ECE/TRANS/WP.29/GRSP/2009/16
23 September 2009

**PROPOSAL FOR THE 01 SERIES OF AMENDMENTS TO REGULATION No. 100
(Construction and functional safety of battery electric vehicles)**

Submitted by the Chairman of the Informal Group on Electric Safety */

Figure 1: Measurement of V_b , V_1 , V_2

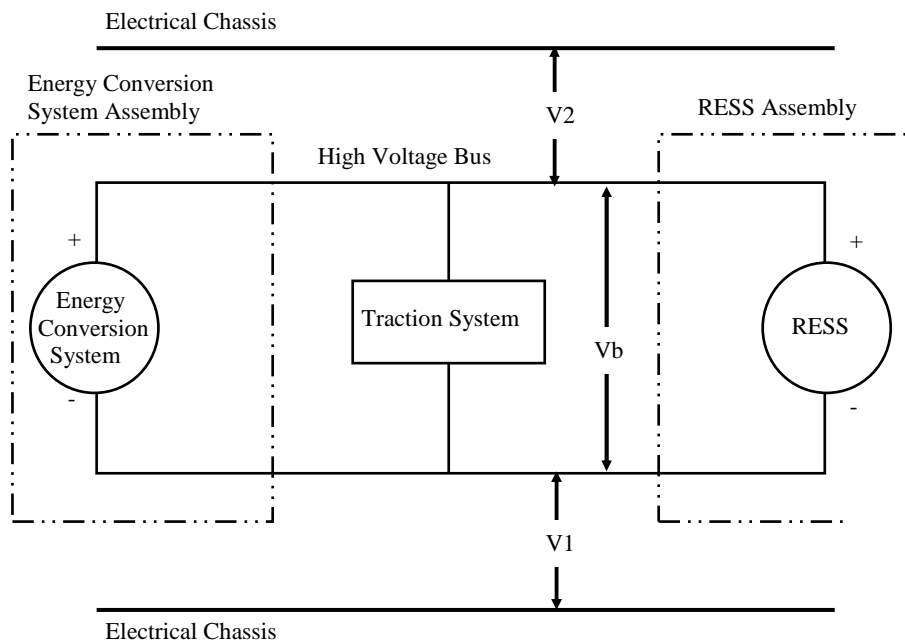
The voltage is measured as shown in Figure 1 and the high voltage Bus voltage (V_b) is recorded. V_b shall be equal to or greater than the nominal operating voltage of the RESS and/or energy conversion system as specified by the vehicle manufacturer.

Measure and record the voltage (V1) between the negative side of the high voltage bus and the electrical chassis (see Figure 1):

Measure and record the voltage (V2) between the positive side of the high voltage bus and the electrical chassis (see Figure 1):

Figure 2: Measurement of V1'

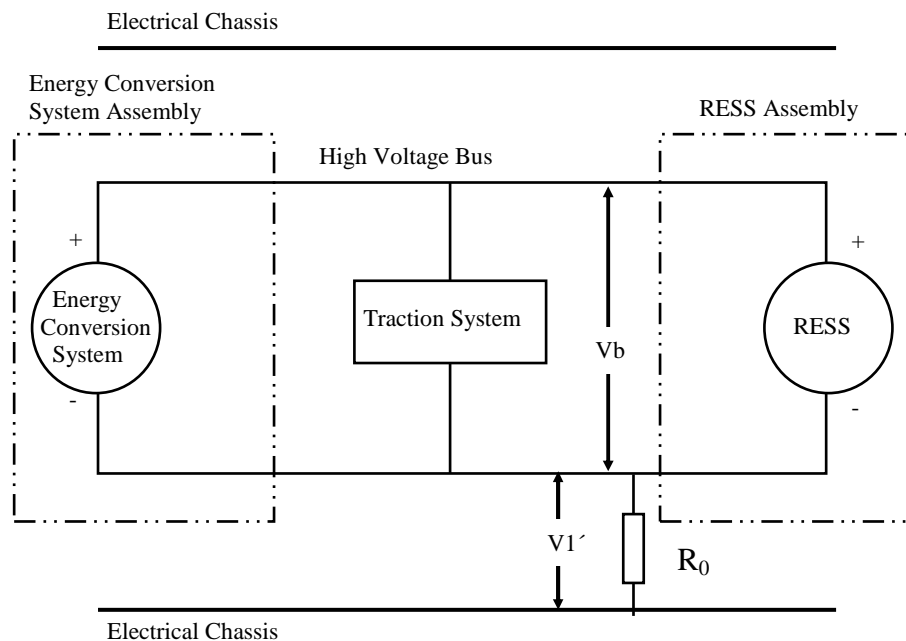
If V1 is greater than or equal to V2, insert a standard known resistance (Ro) between the negative side of the high voltage bus and the electrical chassis. With Ro installed, measure the voltage (V1') between the negative side of the high voltage bus and the electrical chassis (see Figure 2).

Calculate the electrical isolation (Ri) according to the following formula:

$$R_i = R_o * (V_b / V_1' - V_b / V_1) \quad \text{or} \quad R_i = R_o * V_b * (1 / V_1' - 1 / V_1)$$

Figure 3: Measurement of V2'

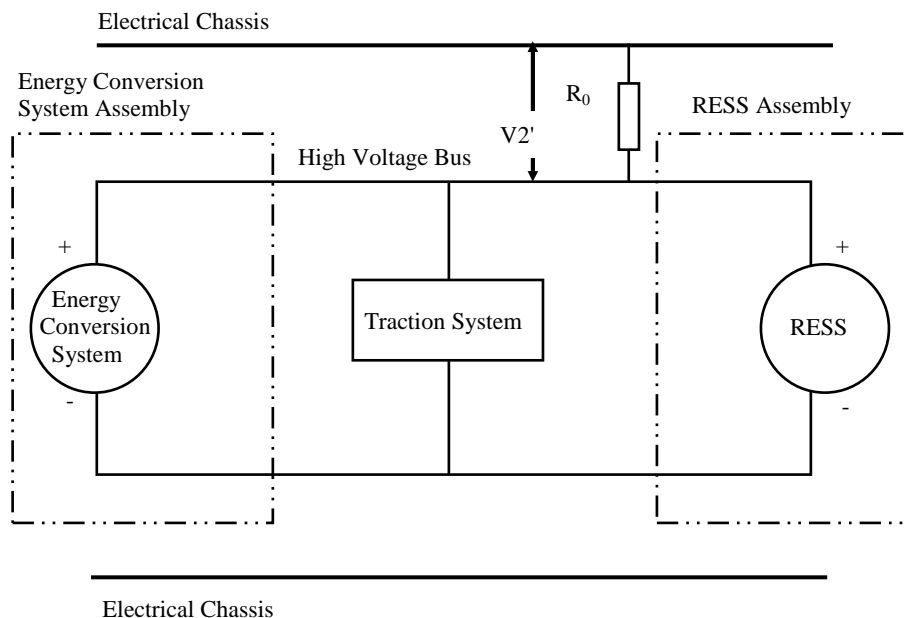
If V2 is greater than V1, insert a standard known resistance (Ro) between the positive side of the high voltage bus and the electrical chassis. With Ro installed, measure the voltage (V2') between the positive side of the high voltage bus and the electrical chassis. (See Figure 3). Calculate the electrical isolation (Ri) according to the formula shown. Divide this electrical isolation value (in ohms) by the nominal operating voltage of the high voltage bus (in volts).

Calculate the electrical isolation (Ri) according to the following formula:

$$R_i = R_o * (V_b / V_2' - V_b / V_2) \quad \text{or} \quad R_i = R_o * V_b * (1 / V_2' - 1 / V_2)$$

~~MEASUREMENT OF THE INSULATION RESISTANCE USING THE TRACTION BATTERY~~

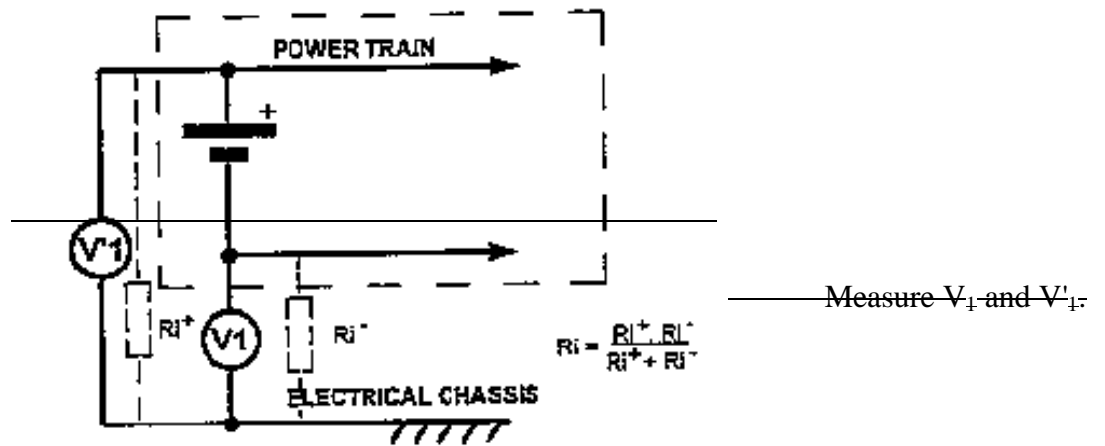
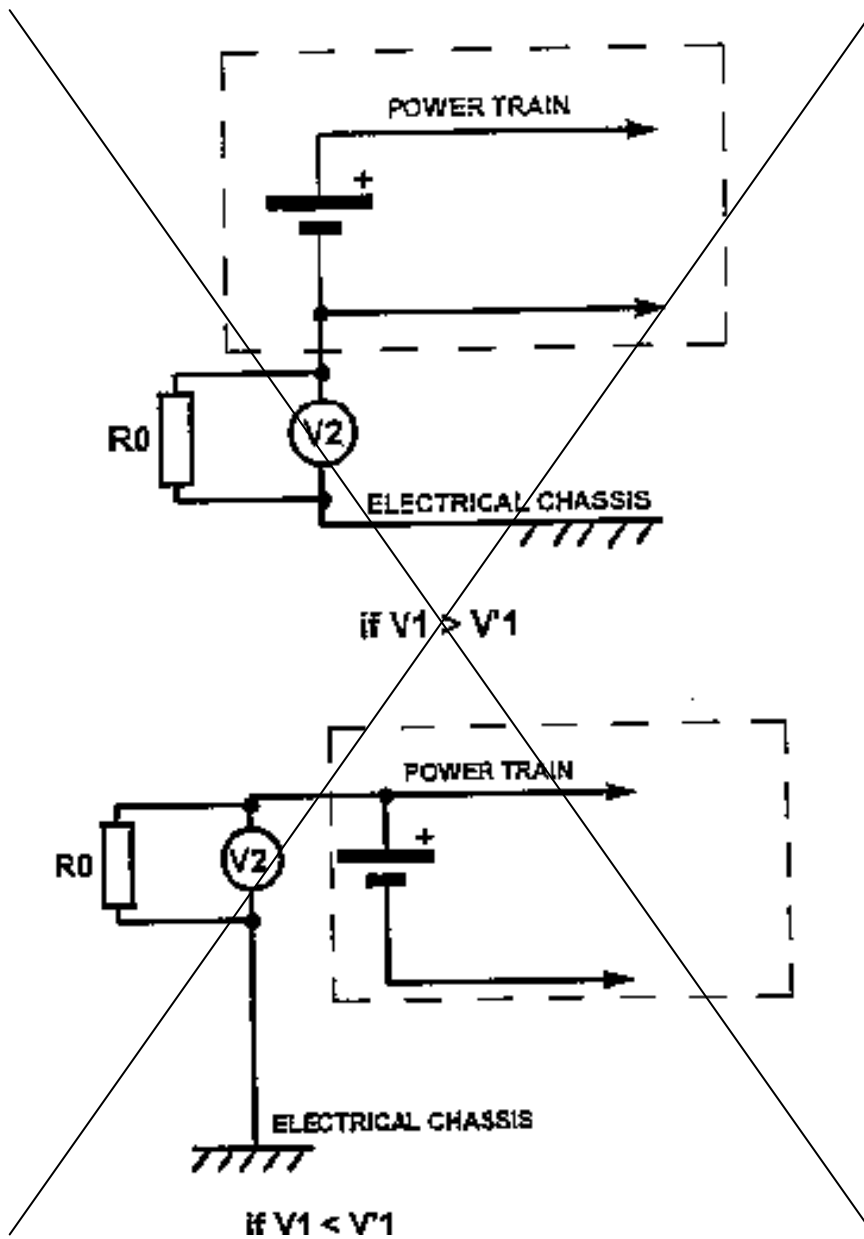
~~1. DESCRIPTION OF THE TEST METHOD~~

~~The traction battery shall be fully charged~~
